Access Compliance Report

Intersection ID: 10038262	Main Street: SMITH_RD	Cross Street: N/A	Location: SW
ADA ID: 197D1C031504	Ramp Type: PerpDiag	Initial Pass/Fail: Fail	Overall Compliance: No
		Severity Score: 35

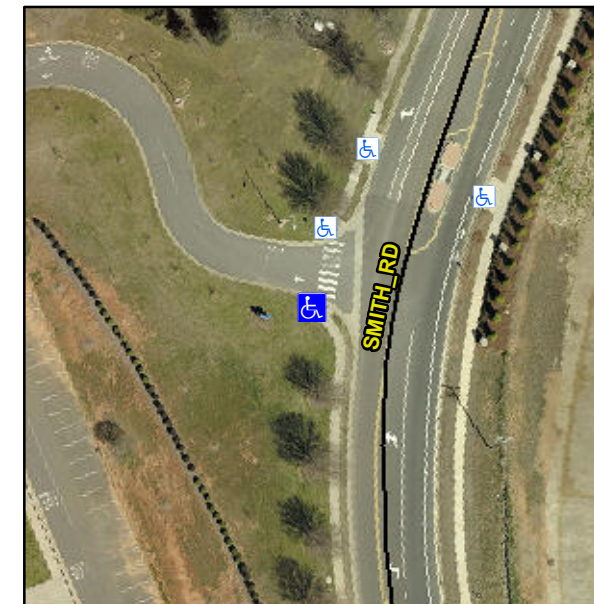
Not Found, R304.5.1, R304.2.2, R304.5.3

Compliance	Description	Data	Compliance	Description	Data
N/A	Ramp Length (in)	47.5	No	Ramp Slope (%)	12.4
No	Ramp Width (in)	47.0	No	Ramp XSlope (%)	4.3
N/A	Flare Type LT	N/A	N/A	Flare Type RT	N/A
N/A	Flare Slope LT (%)	N/A	N/A	Flare Slope RT (%)	N/A
N/A	Flare Traversable LT?	N/A	N/A	Flare Traversable RT?	N/A
N/A	Landing Length (in)	N/A	N/A	DWS Provided?	N/A
N/A	Landing Width (in)	N/A	N/A	DWS Contrast?	N/A
N/A	Landing Slope (%)	N/A	N/A	DWS Length (in)	N/A
N/A	Landing X Slope (%)	N/A	N/A	DWS Full Width?	N/A
N/A	Landing Curb? (Y/N)	N/A	N/A	DWS Offset (in)	N/A
N/A	Shared Landing?	N/A			
N/A	Gutter Ponding?	N/A	N/A	Gutter Slope (%)	N/A
N/A	Gutter Lip Ht (in)	N/A	N/A	Gutter X Slope (%)	N/A
N/A	Painted X Walk1?	No	N/A	Painted X Walk2?	Yes
	X Walk 1 Direction	To E		X Walk 2 Direction	To NE
N/A	X Walk 1 Width (in)	N/A	N/A	X Walk 2 Width (in)	120.0
	X Walk 1 Slope (%)	4.0		X Walk 2 Slope (%)	0.9
	X Walk 1 X Slope (%)	0.2		X Walk 2 X Slope (%)	0.8

Remove & Replace Curb Ramp With Two New Directional Ramps or Equivalent.
